## Product Change Notification / RMES-20LCEZ199

CCB 6369 Initial Notice: Qualification of ASE9 as a new final test site for selected ATMEGA16xx, ATMEGA32xx, ATMEGA644xx, and ATMEGA85xx device families available in 44L TQFP (10x10x1mm) package.

**CCB 6369**  
**Pre and Post Change Summary**  
**PCN #: RMES-20LCEZ199**

# Pre and Post Change – Tape and Reel

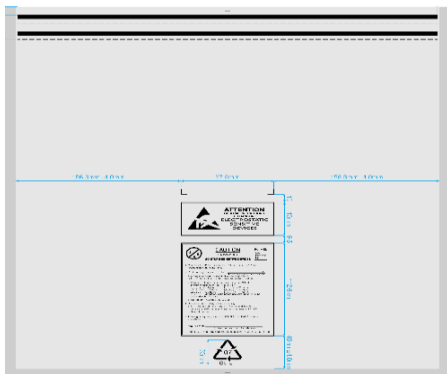
| Final Test Site | Color | Diameter | Hub Dia | W1              | W2               |
| LPI             | White | 330      | 102mm   | 8.4mm<br>16.4mm | 11.1mm<br>19.1mm |
| ASE9            | White | 330      | 102mm   | 8.4mm<br>16.4mm | 11.1mm<br>19.1mm |

# Pre and Post Change – Tape and Reel

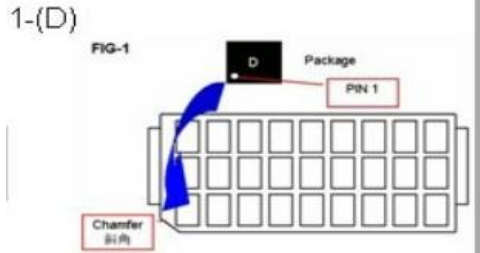
|                      | LPI  | ASE9   |        |        |       |       |       |  |        |       |        |        |       |      |
|----------------------|--|--------|--------|--------|-------|-------|-------|--|--------|-------|--------|--------|-------|------|
| Moisture Barrier Bag | <div></div> <table><tr><th>Length</th><th>Width</th></tr><tr><td>430mm</td><td>470mm</td></tr><tr><td>392mm</td><td>430mm</td></tr></table> | Length | Width  | 430mm  | 470mm | 392mm | 430mm | <div></div> <table><tr><th>Length</th><th>Width</th></tr><tr><td>450 mm</td><td>420 mm</td></tr></table>                            | Length | Width | 450 mm | 420 mm |       |      |
| Pizza Box            | <div></div> <table><tr><th>Length</th><th>Width</th><th>Height</th></tr><tr><td>370mm</td><td>351mm</td><td>53mm</td></tr></table>  | Length | Width  | Height | 370mm | 351mm | 53mm  | <div></div> <table><tr><th>Length</th><th>Width</th><th>Height</th></tr><tr><td>370mm</td><td>353mm</td><td>78mm</td></tr></table> | Length | Width | Height | 370mm  | 353mm | 78mm |
